World Forum for Harmonization of Vehicle Regulations

Proposal for Supplement 19 to Regulation No. 23 (Reversing lamps)

Submitted by the Working Party on Lighting and Light-Signalling*

Figure 1
Marking for single lamps

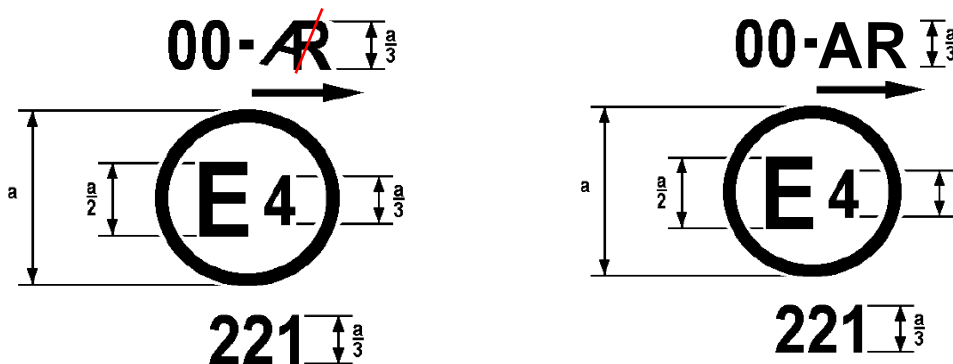
Annex 2, Figure 1, amend to read:
